PLANNED UNIT DEVELOPMENT

<u>& PLANNING APPROVAL REPORT</u> Date: June 4, 2009

DEVELOPMENT NAME First Baptist Church of Carver Homes

LOCATION North side of Whitney Street, 100'± East of Moton Street

SITE PLAN

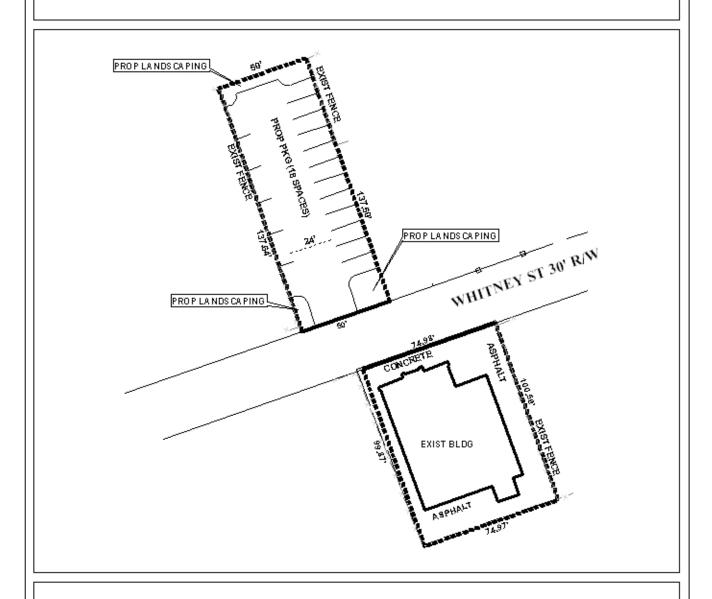
COMMENTS Driveway number, size, location, and design to be approved by Traffic Engineering and conform to AASHTO standards. There is not adequate maneuvering space for the parallel parking spaces as shown. If vehicles parked facing north there is not adequate space to maneuver into or out of the northern most space and there is not adequate aisle width to turn around to exit the parking area. If the vehicles parked facing south, there is not adequate aisle space to turn around to park in the spaces. Changes should be made to eliminate the spaces.

Currently, no parking exists for the church. With that said, the provision of parking would be beneficial, as it would reduce the impact on the surrounding neighborhood by alleviating congestion on the street. However, as noted by Traffic Engineering, there does not appear to be adequate maneuvering area for the parallel parking spaces. If cars parked facing North, then there will not be enough room to maneuver into or out of the Northernmost space. Even if cars were to park facing South, there does not appear to be adequate aisle width for turning around. The applicant should revise the site plan to eliminate the parallel parking spaces. Furthermore, the applicant should also revise the site plan to provide wheel stops.

With regard to trees/landscaping, the lot is currently vacant; thus, new development should require full compliance with Section 64-4.E of the Zoning Ordinance. While the applicant has illustrated some landscaping on the site plan, no calculations have been provided. If substandard, then some parking will need to be removed, or a variance application will be required. The same applies to trees, as it appears that full compliance will certainly require the removal of some parking.

The site is completely surrounded by residentially zoned properties; thus, a buffer, in compliance with Section 64-4 of the Zoning Ordinance is required around the boundary of both the existing church site and the parking lot. Additional screening along the street should also be required, where the parking lot is across from residentially zoned properties. Furthermore, as required by Section 64-6.A.3.c of the Zoning Ordinance, any lighting for the parking lot shall be so arranged that the source of light does not shine directly into adjacent residential properties or into traffic.

There is no indication on the site plan as to the proposed location of any dumpster or other waste storage facility. The location of the storage area for the dumpster must be illustrated on the site plan and labeled, and the location and required screening must comply with Section 64-4.D.9 of the Zoning Ordinance, as well as with all other applicable regulations. If no dumpster is to be provided, then a note must be placed on the site plan stating so.

- 1) Submission of a revised site plan addressing parking issues referenced by Traffic Engineering;
- 2) Submission of an application for a one-lot subdivision; and
- 3) Submission of applications to the Board of Adjustment, if necessary.
